2. Carl & Emma Clark Estates #2 KPB File 2023-012

ITEM 1 - CARL & EMMA CLARK ESTATE #2

KPB File No.	2023-012
Plat Committee Meeting:	February 27, 2023
Applicant / Owner:	Ronald Wilson of Hope Alaska
Surveyor:	Jerry Johnson / Johnson Surveying
General Location:	Hope Highway, Hope, Hope/Sunrise APC

STAFF REPORT

Vicinity Map

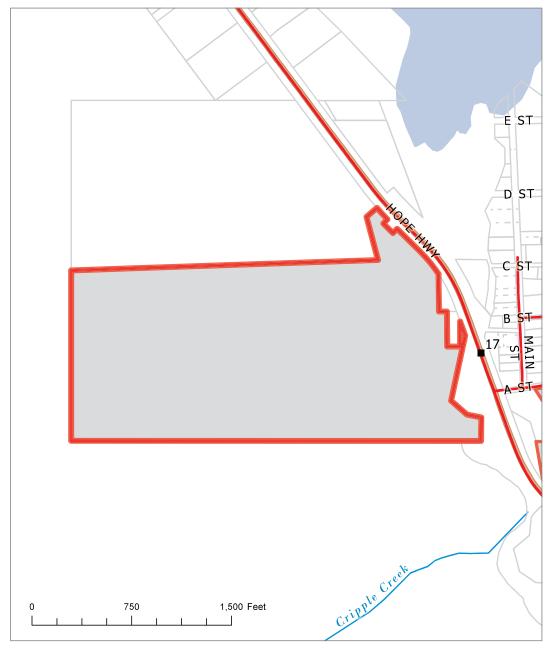
There appears to be some discrepancy on the boundary of the subdivision to the section lines. A Record of Survey was done and recorded, SW 2008-03. Per that record of survey, a portion of Tract B is within the southeast portion of Section 29. **Staff recommends** the surveyor verify the location of the section corner and depict the location in relation to the subdivision, amend the location description in the title block, and update the depiction within the vicinity map.

- D. A vicinity map, drawn to scale showing location of proposed subdivision, north arrow if different from plat orientation, township and range, section lines, roads, political boundaries, and prominent natural and manmade features, such as shorelines or streams;
 - Staff recommendation: Update depiction
- F. The location, width and name of existing and platted streets and public ways, railroad rights-of-way, easements, and travel ways existing and proposed, within the subdivision;

Staff recommendation: Update the location to include portion within Section 29
